Review of the Three Lakes Water Quality Model and the Colorado-Big Thompson RiverWare Model, Colorado

Prepared for
United States Bureau of Reclamation
Great Plains Region
Eastern Colorado Area Office

October 2018

Figure 34: Ratio of daily evaporation in 3 lakes

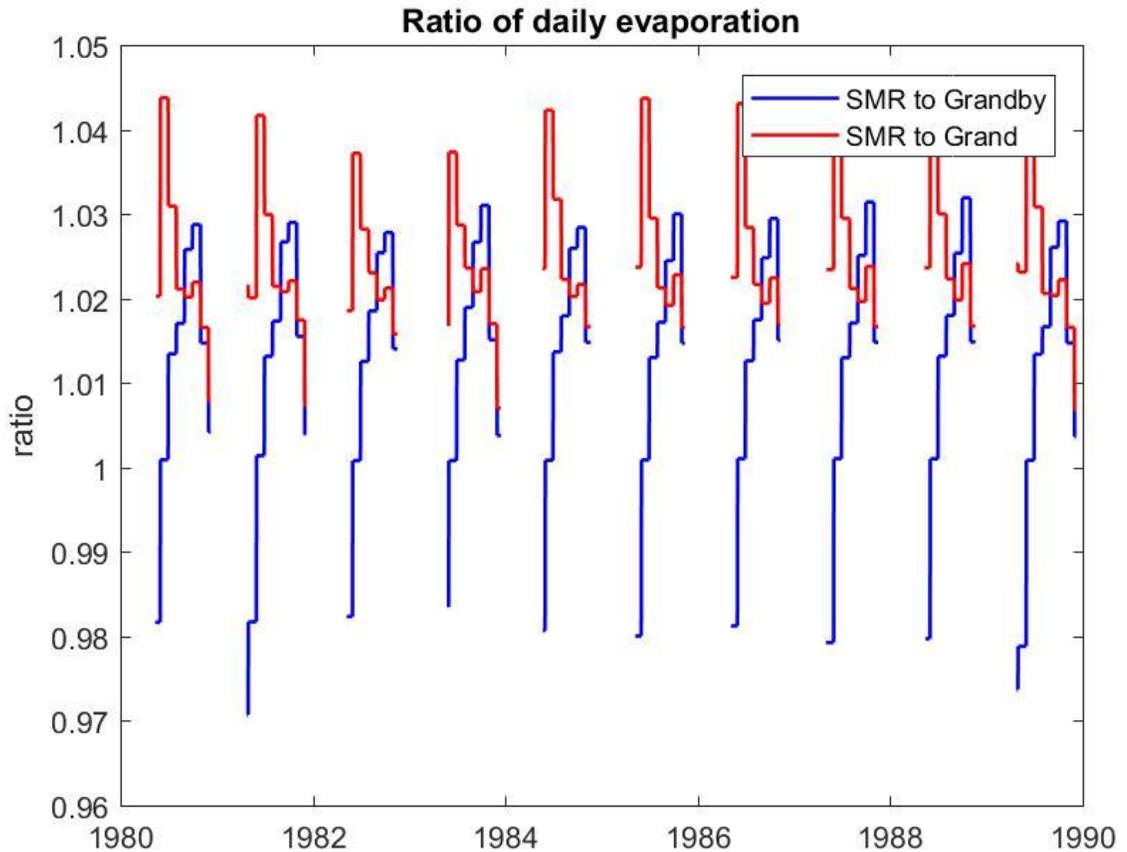
As shown in Figure 34, the evaporation ratio calculated in Granby, Grand Lake, and Shadow

Mountain Reservoir vary seasonally. It would be good to document whether this is a realistic feature of the data, or is an artifact of calculation. While it is possible/probable that this is a feature of water temperature in the different lakes, it would be recommended to determine whether a variable ratio makes sense, given available physical data. Moreover, it can be seen that the ratio varies month to month in a staircase pattern, not smoothly as might be expected. The implications of the “stair-case” structure on results, while probably not a huge factor, should be considered.

Figure 35: Precipitation and Evaporation into Granby and Shadow Mountain reservoir, from Hydros data.

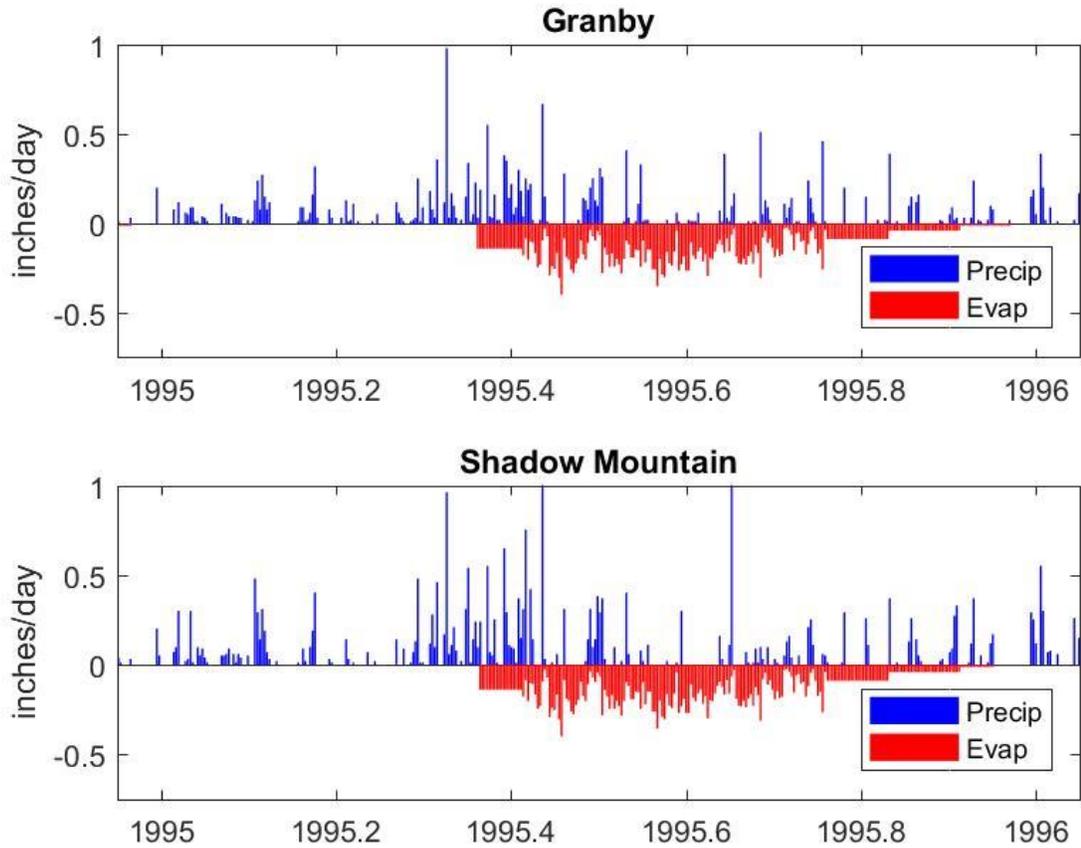
- 6) The actual precipitation and evaporation values produced by Hydros should be checked for consistency (see Figure 35). For example, there is no evaporation during some months which is probably due to ice formation. That assumption though is not in the documentation. Similarly, the first and last months with evaporation are often block averages, rather than day-to-day values. It would seem that better estimates could be made, especially as there seems to be an inverse correlation between precipitation and evaporation. Comparing precipitation values, some events occur in Granby but not in Shadow Mountain, or vice versa. While this may be the effect of locally variable precipitation (e.g., thunderstorms), it is a legitimate question to ask whether the precipitation values which are measured at stations removed from the lake are

correct for the lake, or whether local variability produces error. One could consider checking the precipitation values with reanalysis data or other sources of data, if available.

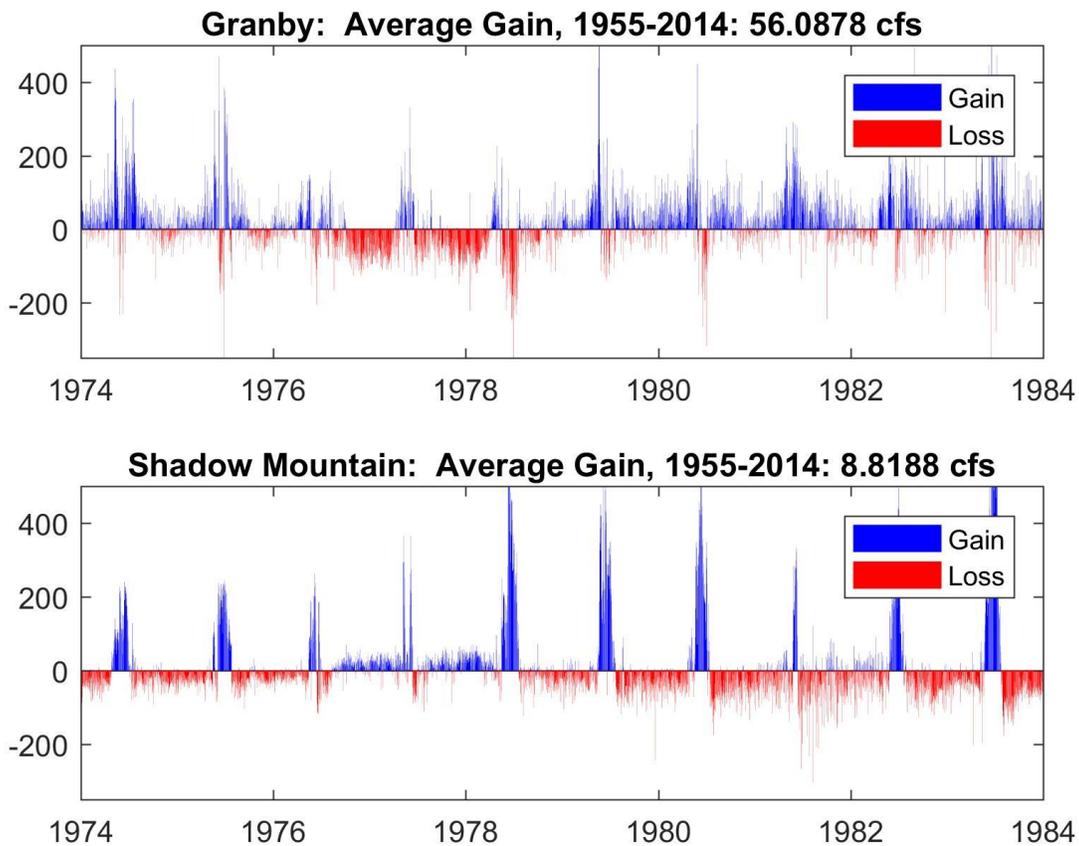
Overall, the patterns of “loss” and “gain” in the reservoirs (the correction term) should be investigated. By figuring out the reasons, one may determine the best way to improve the model. For example, the average gain/loss for Shadow Mountain and Granby are sometimes inversely correlated, in a way that might suggested unged or unrecognized flows from one lake to the other (see Figure 36). If so, these might be investigated to determine the reason. One possibility is the observation (p. 17 of Hydros document) that the imputation for the Shadow Mountain dam radial gate release is fairly large, percentage-wise, for low flow--an envelope of +/- 500 cfs or so. If such errors are auto-correlated over time, it might lead to periods of bias or greater error. The observed increase in residuals to Granby after 1990 per the Hydros document (p. 20) should be investigated.

Figure 37. Model predicted ortho-phosphate fluxes in Grand Lake.

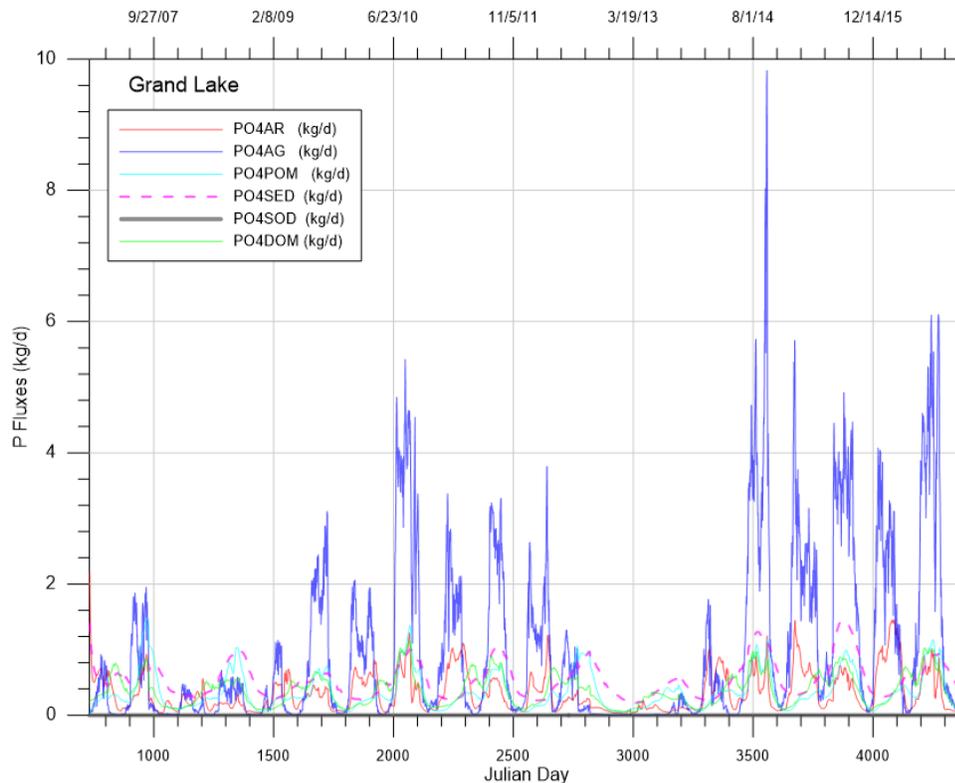
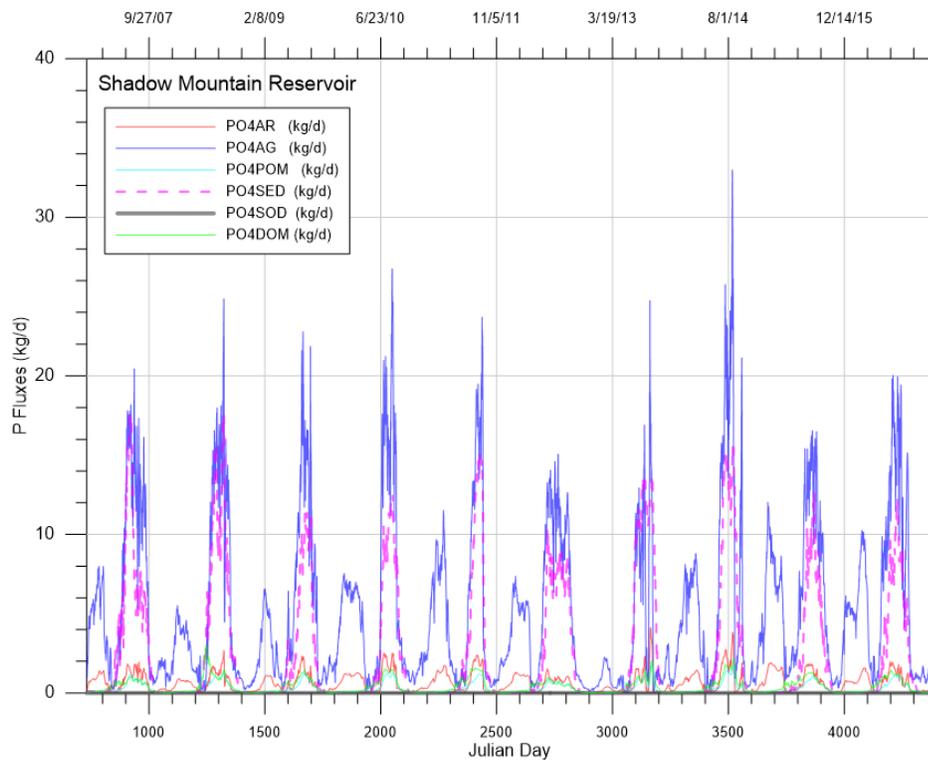
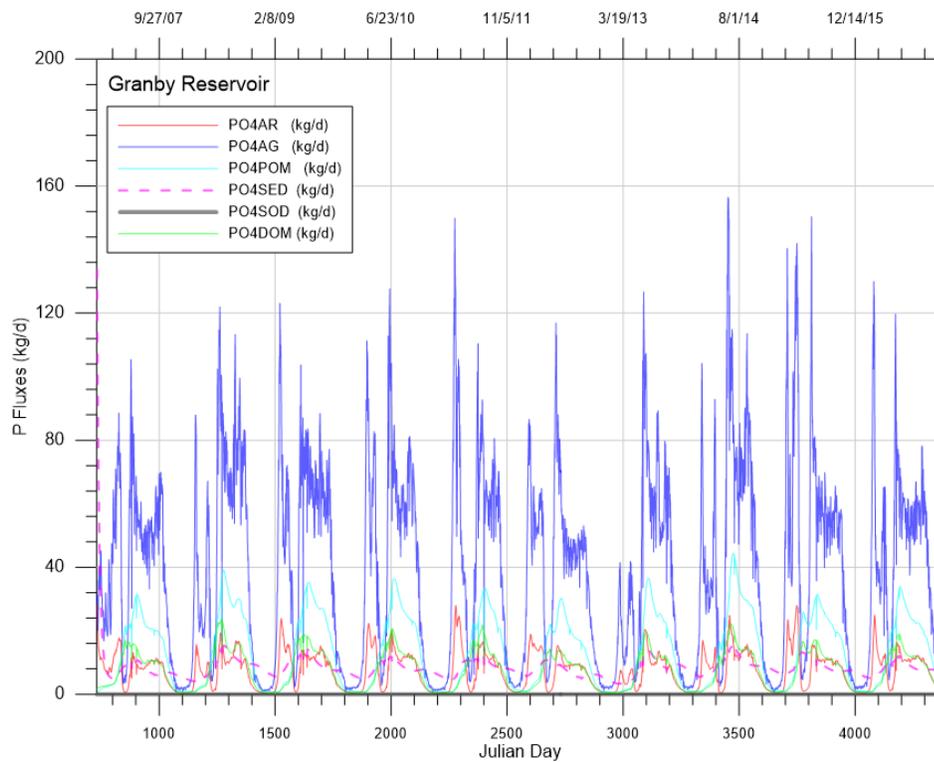
<p data-bbox="440 1218 1360 1404">As shown in the nutrient flux section in Appendix A (Figure 37 through Figure 39), releases of ortho-phosphate due to first-order sediment decay are a relatively large source in Shadow Mountain when compared to Grand Lake and Shadow Mountain Reservoir. Calibration would likely be improved if this large source was decreased by reducing the fraction of POM settling out of the water column and/or reducing the P fraction in POM.</p>	Water Body	Number of Observations	Mean Error (ug/L)	MAE (ug/L)	RMSE (ug/L)	MAE (% of Range)	Grand Lake	206	1.79	2.30	2.89	35%	Shadow Mountain Reservoir	410	3.11	3.63	4.75	32%	Granby Reservoir	206	1.55	2.37	3.28	13%
Water Body	Number of Observations	Mean Error (ug/L)	MAE (ug/L)	RMSE (ug/L)	MAE (% of Range)																					
Grand Lake	206	1.79	2.30	2.89	35%																					
Shadow Mountain Reservoir	410	3.11	3.63	4.75	32%																					
Granby Reservoir	206	1.55	2.37	3.28	13%

Figure 52. Precipitation constituents 2 (Solid flat lines imply a constant value of the constituent over time).

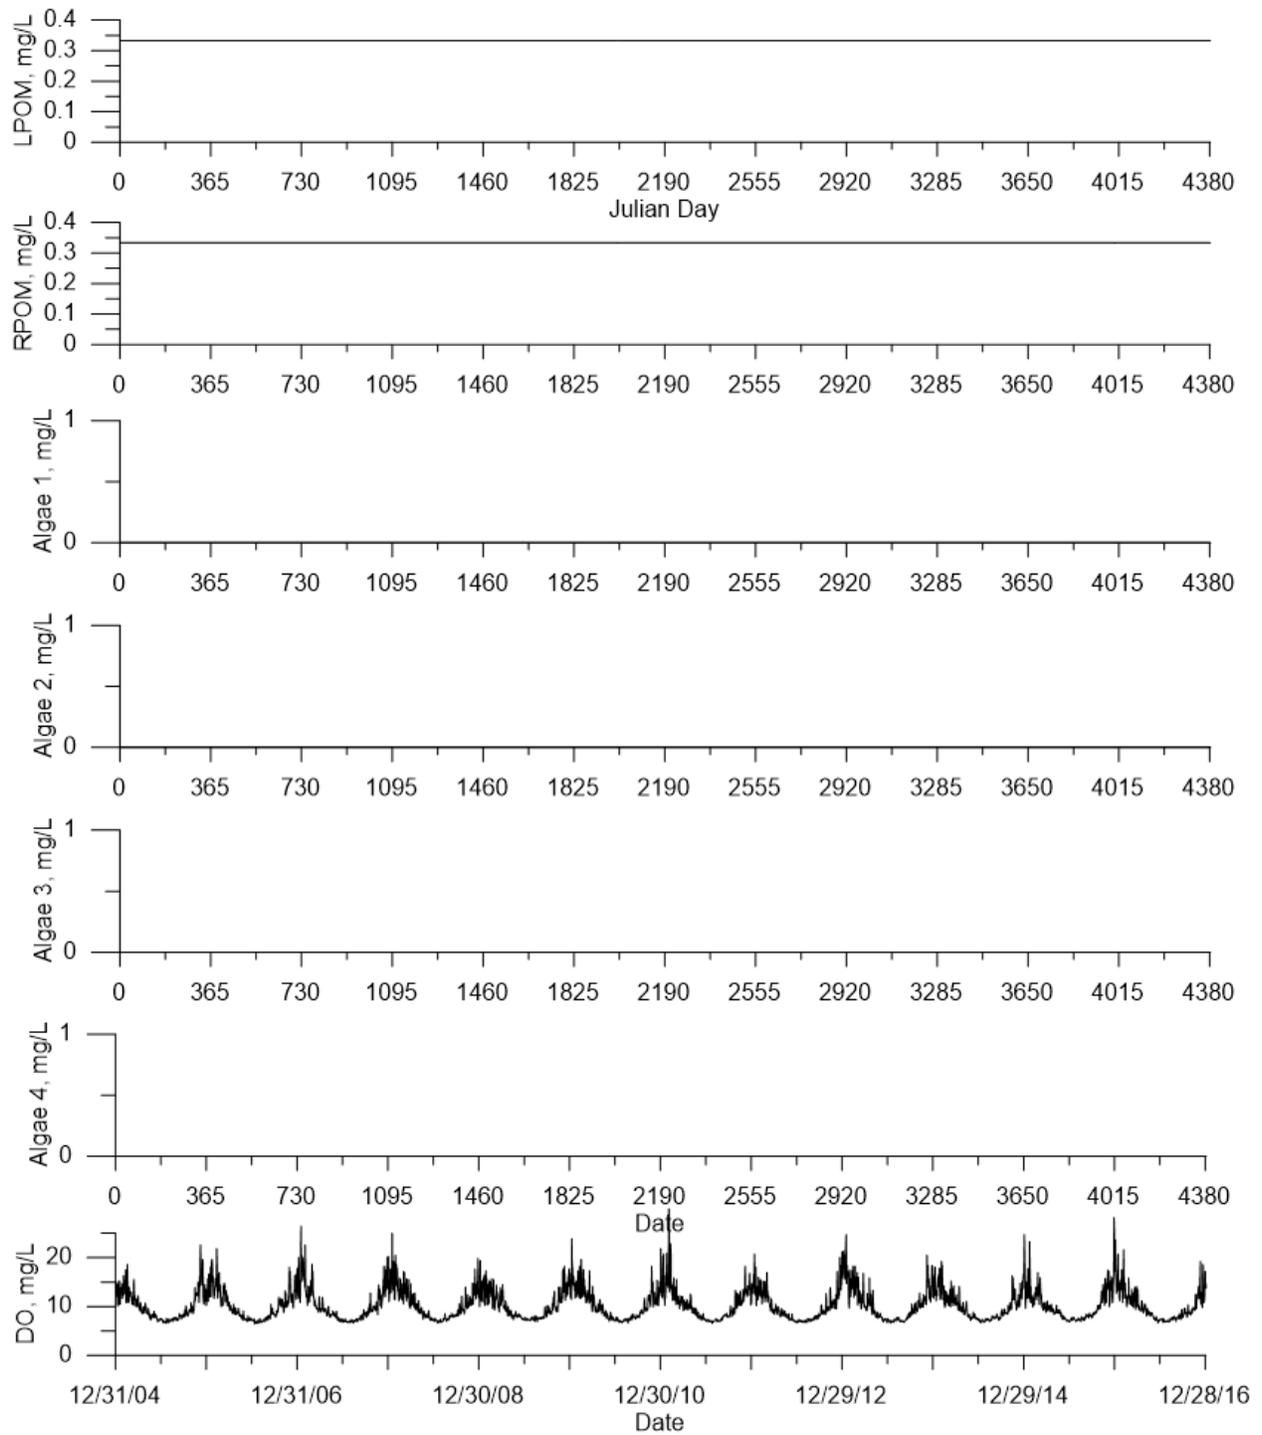
#	Subject, Location	Comment
47	Precipitation concentration, file 'Cin_Precip.npt'	Dissolved oxygen concentrations in the precipitation are often above 20 mg/L and are too high (Appendix B, Figure 52). A saturated DO concentration in freshwater at sea level at 0°C is about 14.6 mg/L and would be lower at higher elevations due to decreased barometric pressure.
48	East Inlet Branch Constituent Inflow, file 'cin_el.npt'	Constituent concentrations are repeated after Julian Day 4017 – see Appendix B Figure 59 through Figure 62.
49	North Fork Constituent Inflow, file 'cin_NF.npt'	At low concentrations of LPOM or RPOM (0.0025 mg/L), $LPOM < LPOM_P + LPOM_N$ and $RPOM < RPOM_P + RPOM_N$. Total organic matter mass cannot be less than the sum of organic matter nitrogen and phosphorus (see Appendix B Figure 67 and Figure 68).
